SKEP III Home Office Support Site Visit Report

Consultant	Wahib Medanat Consultant Engineer	Rep No.	23-27032022
Contractor	Dijlah Establishment Constr. Contracting	Tender No.	(11/2019/USAID/SKEP/3/S) Schools for a Knowledge Economy Project (SKEP) - Phase (3) Package (1, 2)
Site Name	Jumana Bint Abit Taleb Basic Mixed School - Jerash	Day/ Date	Sun. 27/03/2022
Duration of Project	450 Calendar Days	Total Project Budget	8,314,983.735 JD

(Figure: 10)

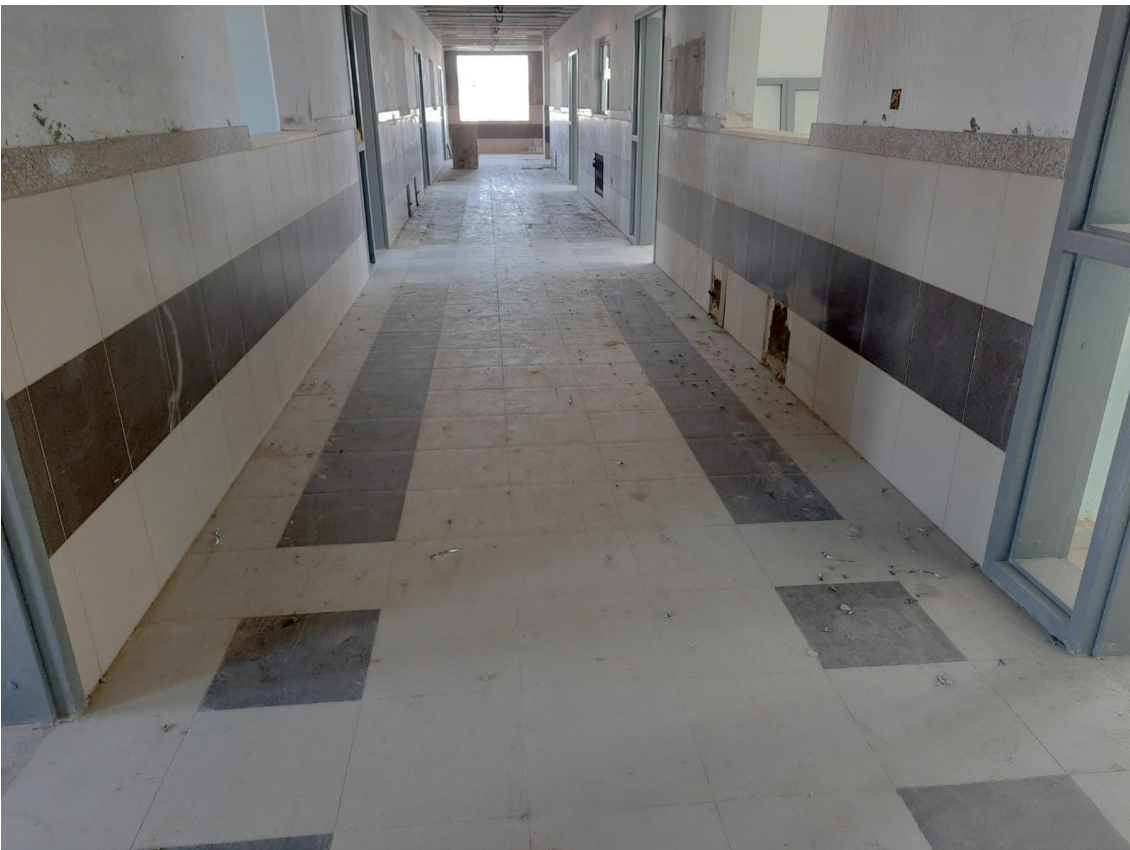
The team inspected the executed granite for staircase parapets
